Mottagare: Kontrollanter, kontrollantelever, CI alla klubbar		Datum: 2019-10-14	Bilag: Service Bulletin	Blad nr: 1 av 1
		Ärende: Materielmeddelande nr. 2019/4		
Fastställt av MK: 2019-10-14	Ersätter:	Utfärdare: SFF Materielkommitté (MK)

Service Bulletin 2018-001

Subject: Upgrade reserve cover flap

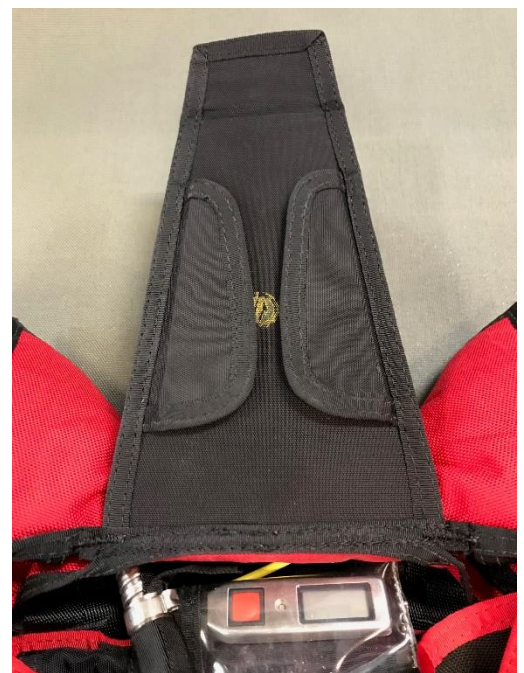
SIFE is offering an upgrade on the reserve cover flap.

We have been informed that during the annual reserve repack the reserve container opened with a delay of 0,18 seconds after pulling the reserve ripcord handle. The reserve cover flap wasn't moved or opened before the reserve ripcord handle was pulled.

The result of our investigations is that an increased friction between the reserve cover flap and the reserve container can lead to the unlikely event of a short delay of the opening of the reserve container.

1. Make sure that the reserve cover flap and the reserve container is clean before jumping.
2. Open the reserve cover flap to check your pin, the reserve loop and your Cypres before jumping.

We are offering an upgraded reserve cover flap free of charge to all our customers who own an affected container size.
